Consultation on Scottish Hydro Electric Transmission's MSIP Re-opener (Skye Dynamic Line Rating Project)

Subject	Details
Publication date:	27 June 2022
Response deadline:	25 July 2022
Contact	Jack Schuler
Team:	RIIO Electricity Transmission
Telephone	020 7901 7414
Email:	riioelectricitytransmission@ofgem.gov.uk

We¹ are consulting on the needs case and preferred option for SHET's proposal to install a Dynamic Line Rating system on the 132kV Skye circuit between Edinbane and Broadford. We would like views from people with an interest in electricity transmission and distribution networks. We would also welcome responses from other stakeholders and the public.

Figure 1: The 132kV Skye Transmission line

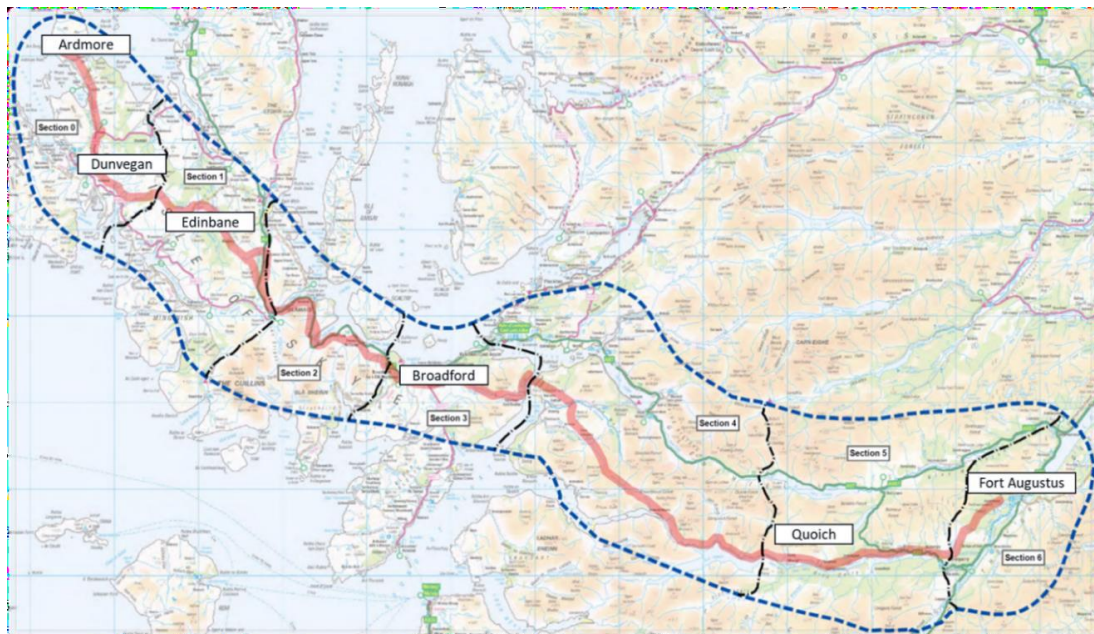
3.1. The Skye transmission network consists of a single radial 132kV overhead line (OHL) extending over 160km. As shown below in Figure 1, it connects the 400kV substation at Fort Augustus on the mainland to Ardmore on the Isle of Skye.

3.2. Due to the level of generation proposed to connect to the system exceeding circuit capability,¹² SHET were granted a derogation from Ofgem in 2010 in relation to compliance with the Section 2 'Generation Connection' criteria of the System Quality and Security of Supply Standard¹³ (SQSS) for the Western Isles, Skye and Lochaber area.¹⁴ This area includes the 132kV Skye circuit.

Figure 2: Example of analysis undertaken to determine seasonal DLR rating

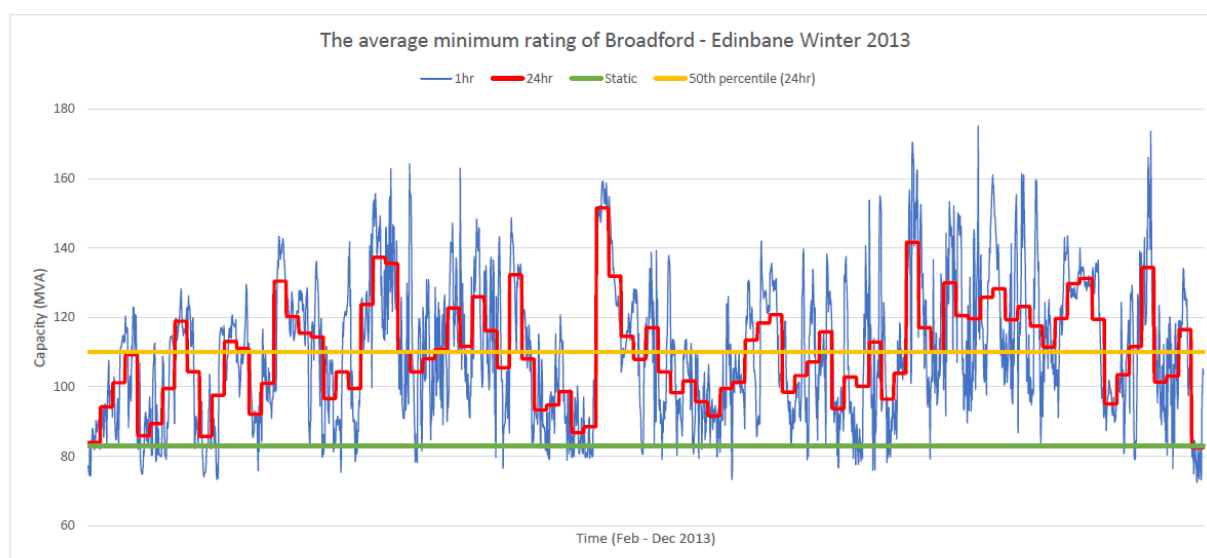
4.13. Using Met Office weather data from 2013, SHET carried out statistical analysis on a rating calculation model of the OHL to establish a credible seasonal rating increase to feed into the studies to determine seasonal capability uplift. 2013 was selected as this was considered a typical year and would therefore mitigate the impact of annual variability on the estimations. An example of this analysis has been included below in Figure 2.

4.14. For each day of summer, spring, autumn, and winter in 2013, SHET calculated the average minimum rating for DLR. The median calculated seasonal rating for winter, spring/autumn, and summer corresponded to ratings of 110MVA, 98MVA, and 86MVA respectively. SHET selected the median ratings as it considers this provides a rating which is neither overly optimistic nor pessimistic on the potential application and benefit of DLR.
